ADDENDUM NO. 1  
NEW FACILITIES FOR  
BENTON GAS SYSTEM  
BENTON, KENTUCKY

October 12, 2010

**MECHANICAL AND ELECTRICAL ADDENDUM 1.00**

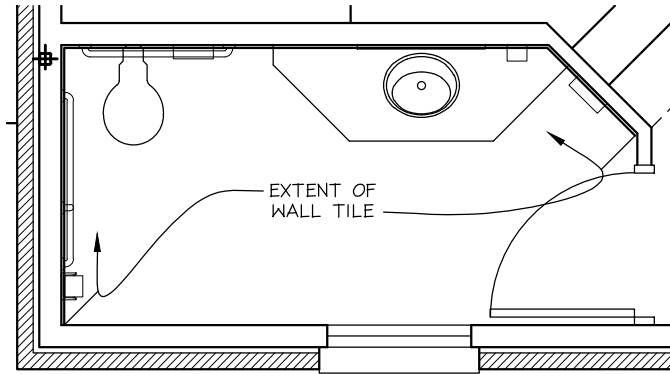
**ITEM NO. 12 -SHEET A-11 – FOUNDATION PLAN – BUILDING “B”**

Foundation Detail B – Change target notation from E / A-11 to F / A-11 and Column 1 to A.

**DRAWING TITLE**  
**ADDENDUM 1**  
**ITEM No. 4**

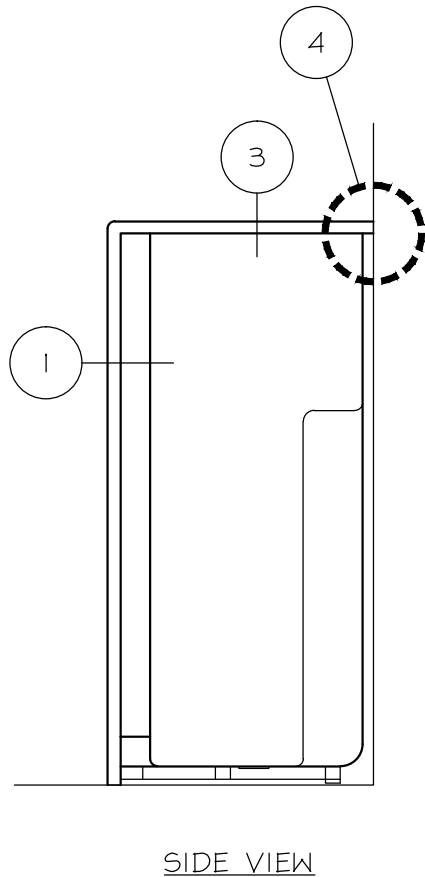
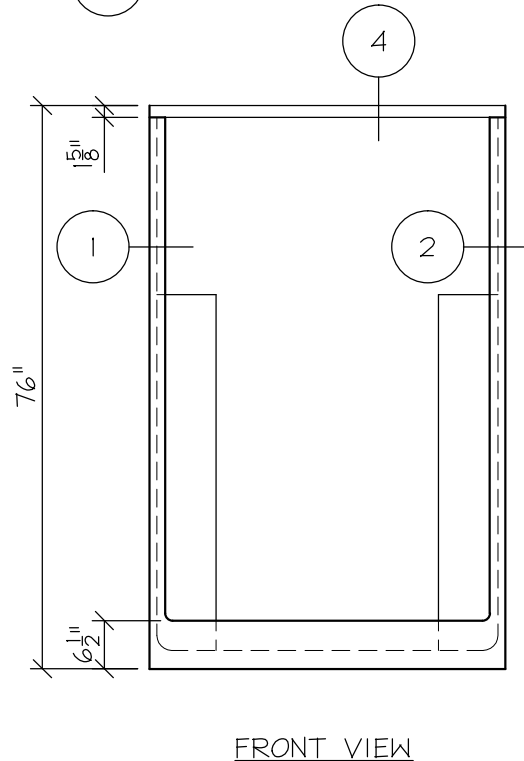
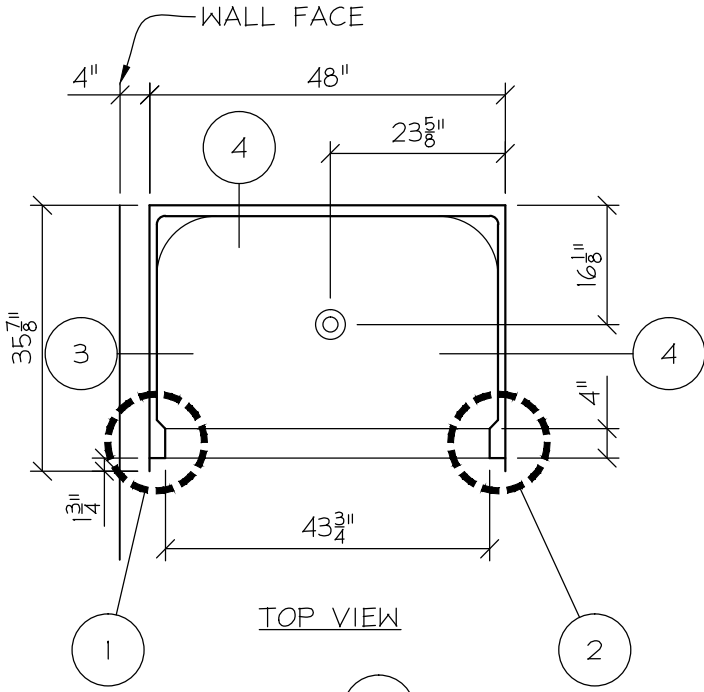
**ITEM NO. 4 - SHEET A-2 – FLOOR PLAN – BUILDING "A"**

Refer to attached Partial Plan drawings showing extent of wall tile in toilet rooms as referenced in Finish Schedule.

WOOD TRIM DETAILS @ SHOWER BLDG. "B"

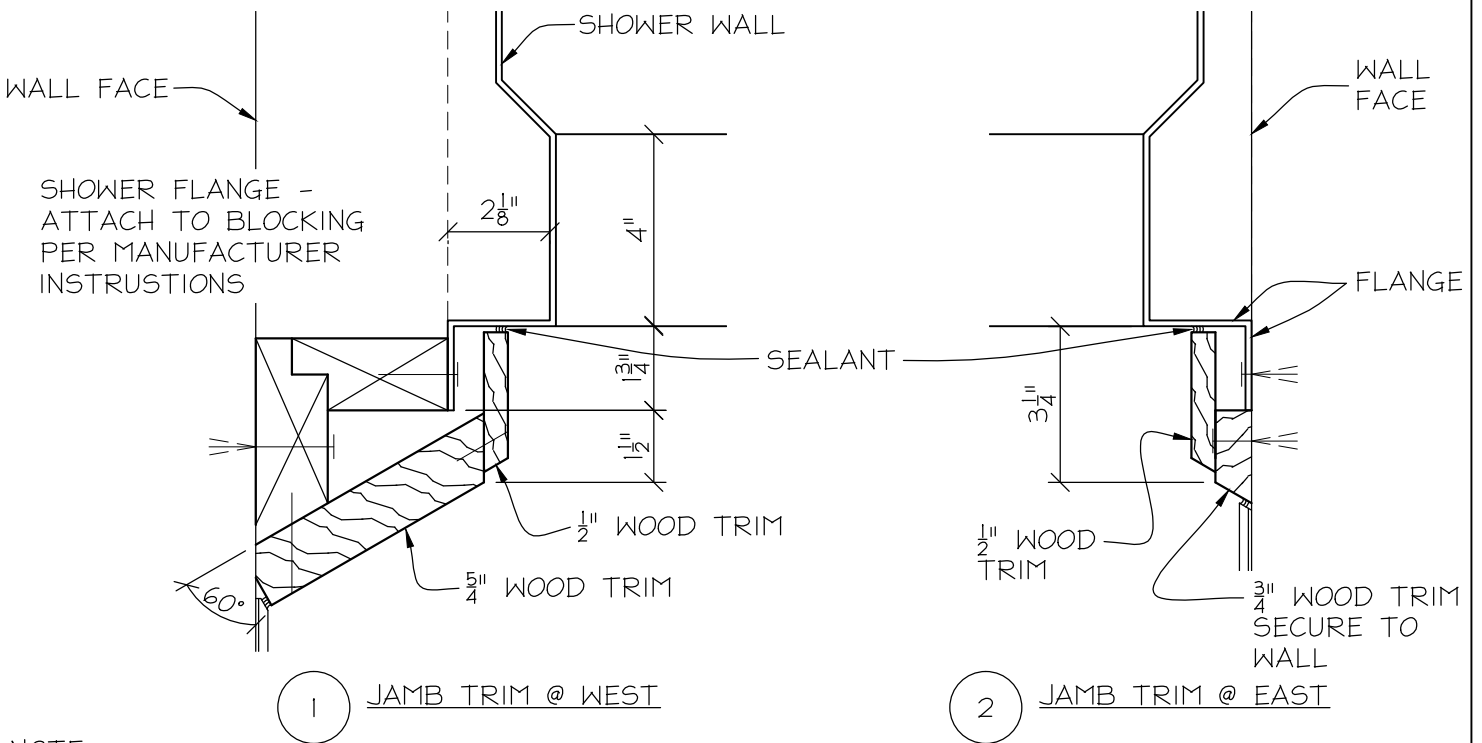
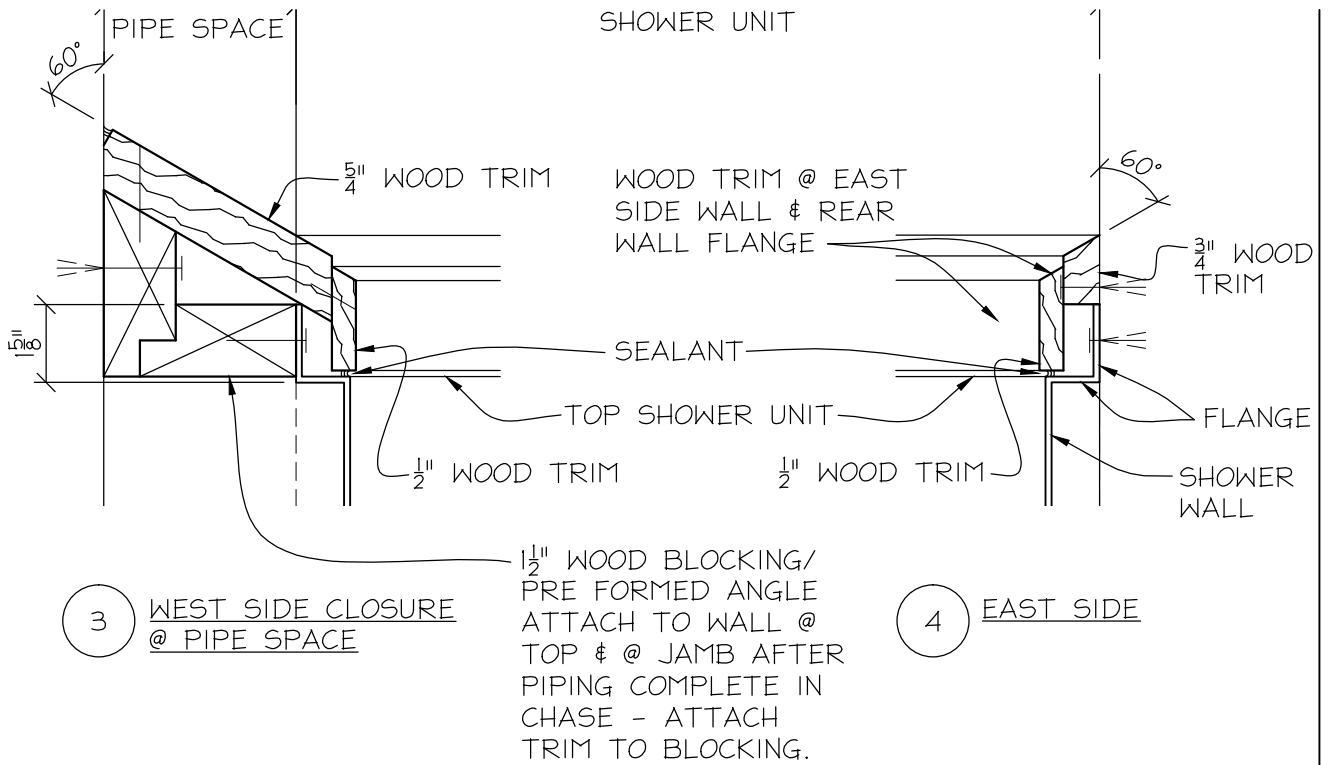
- ITEM NO. 18 -SHEET A-13 – SECTIONS/ DETAILS – BUILDING “B”**  
Section D / A-13 – Note that detail is typical for conditions for 4” conc. and 6” conc. slab and areas along offset concrete block walls near Column Line 2 – where slab thickness changes from 4” to 6”.

PLUMBING FIXTURES

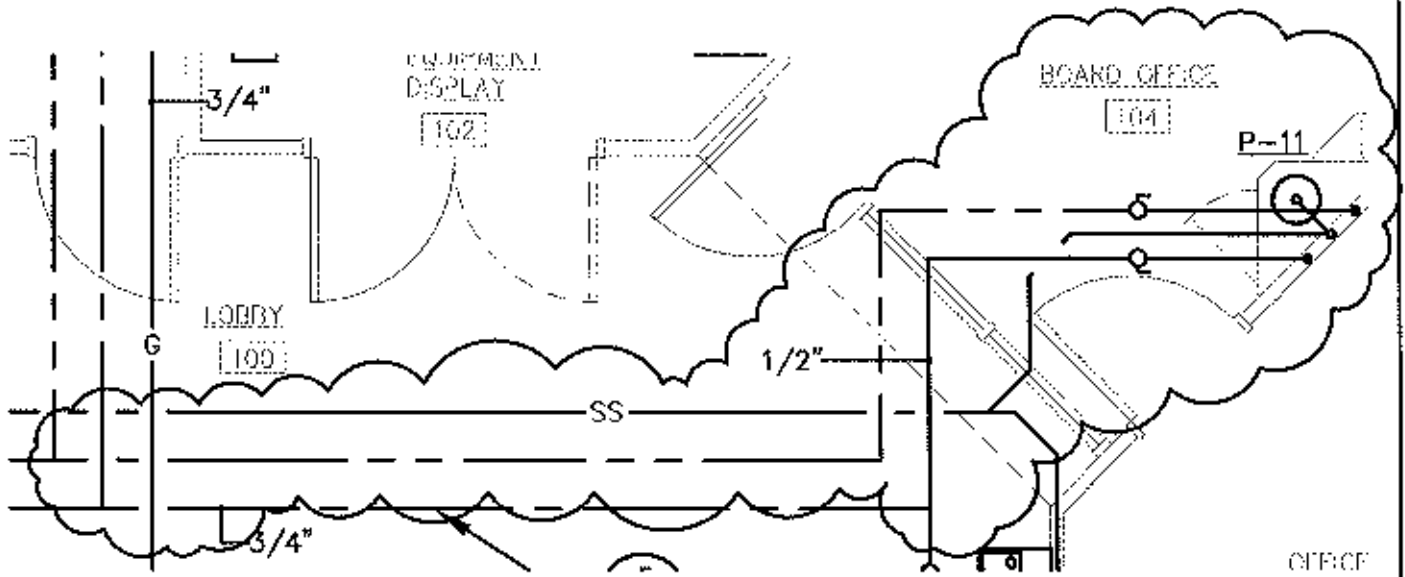
- 1.01 Reference drawing U-1. Detail 19, P-6 shall be revised to indicate the underground natural gas piping to the lamp posts. See drawing U-2 for electrical site details.
- 1.02 Reference drawings P-1, P-2, and P-4, and attached sketches XP01, XP02, and XP03. Contractor shall furnish and install a bar sink for Board Office 104 as specified in the attached sketch XP01. Revise domestic water piping and DWV riser as shown in attached sketches XP02 and XP03.
- 1.03 Reference drawings P-3 and H-3. Coordinate gas piping to natural gas fired infrared heaters on P-3 with unit locations on H-3.
- 1.04 Reference drawing E-2. The receptacle in Board Office 104, mounted northeast of the door to enter Office 3 103, shall be mounted above casework per detail on E-9. Coordinate height with casework, see Architectural. Receptacle shall be GFCI type.
